**SUNDRY NOTICES AND REPORTS ON WELLS**  
*Do not use this form for proposals to drill or to re-enter an abandoned well. Use Form 3160-3 (APD) for such proposals.*

**ConocoPhillips**  
**SAN JUAN 29-6 UNIT 13**  
**Expense - P&A (PROPOSAL)**

Re: Permanent Abandonment  
Well: San Juan 29-6 Unit 13

CONDITIONS OF APPROVAL

## Schematic - Current SAN JUAN 29-6 UNIT #13

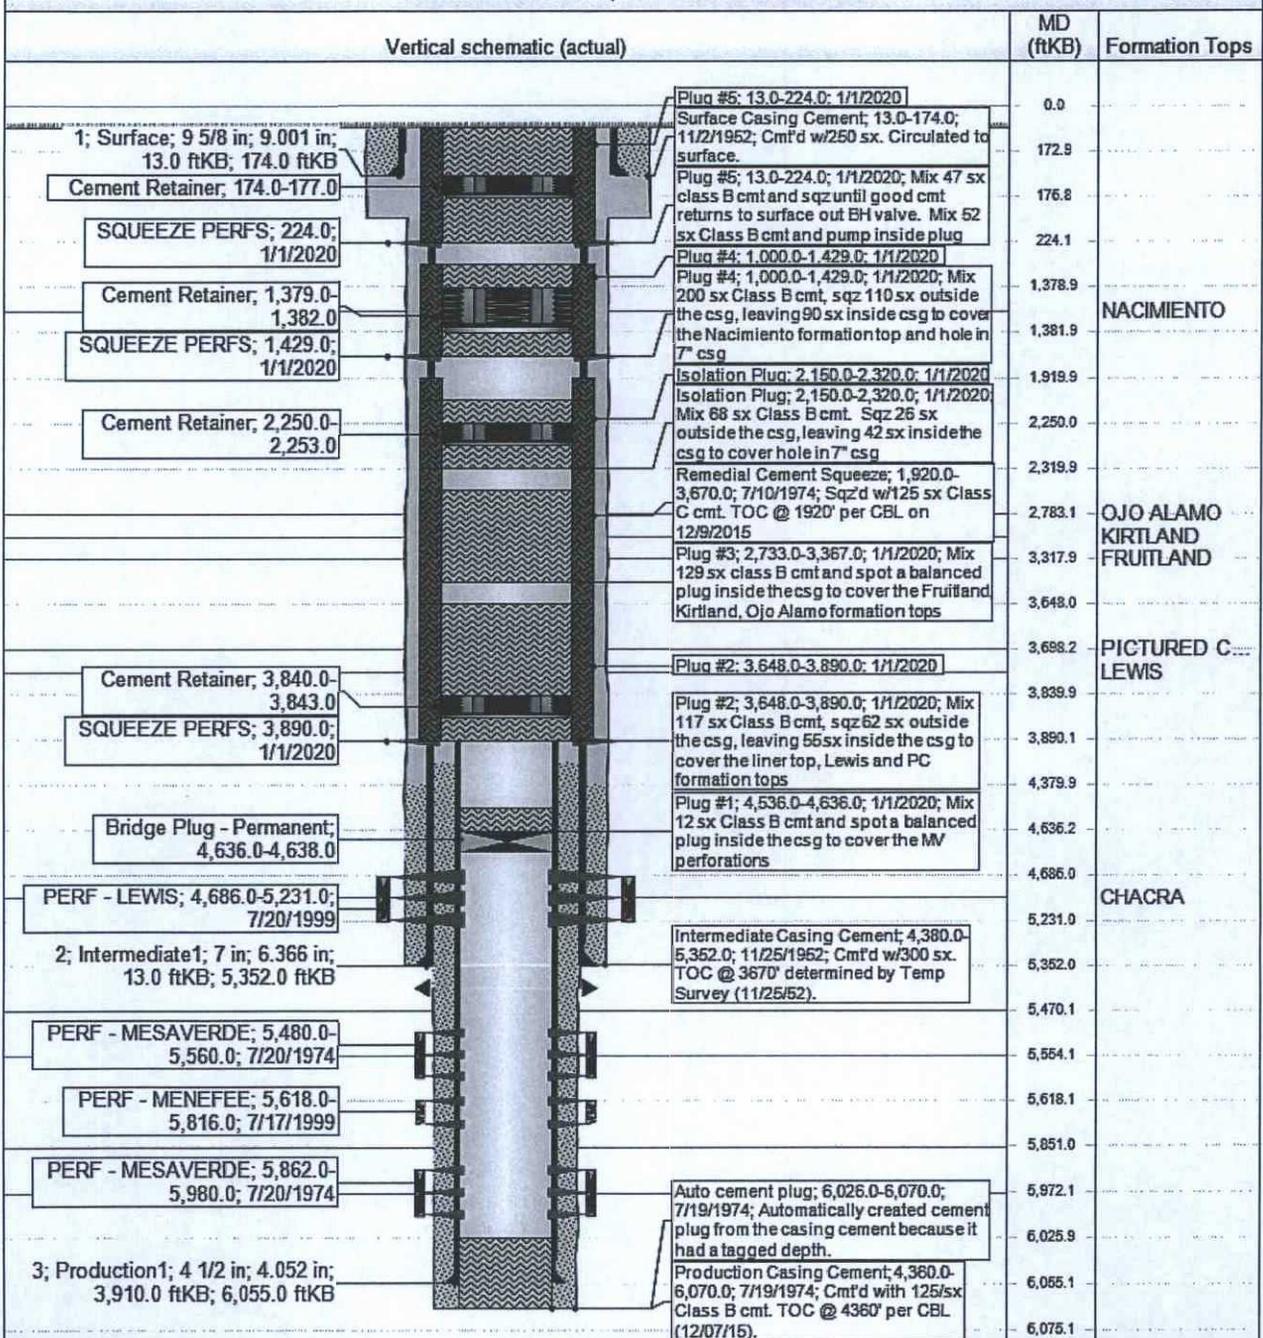
- a) Bring the top of plug #1 to **4351 ft.** to cover the Chacra top. **BLM picks top of Chacra at 4401 ft.** Adjust cement volume accordingly.
- b) Bring the top of plug #2 to **3632 ft. inside/outside** to cover the Pictured Cliffs top. **BLM picks top of Pictured Cliffs at 3682 ft.** Adjust cement volume accordingly.
- c) Set plug #3 (**3392-2650**) ft. to cover the Fruitland, Kirtland, and Ojo Alamo tops. **BLM picks top of Fruitland at 3342 ft. BLM picks top of Ojo Alamo at 2700 ft.**
- d) Set plug #4 (**1507-1407**) ft. **inside/outside** to cover the Nacimiento top. **BLM picks top of Nacimiento at 1457 ft.**
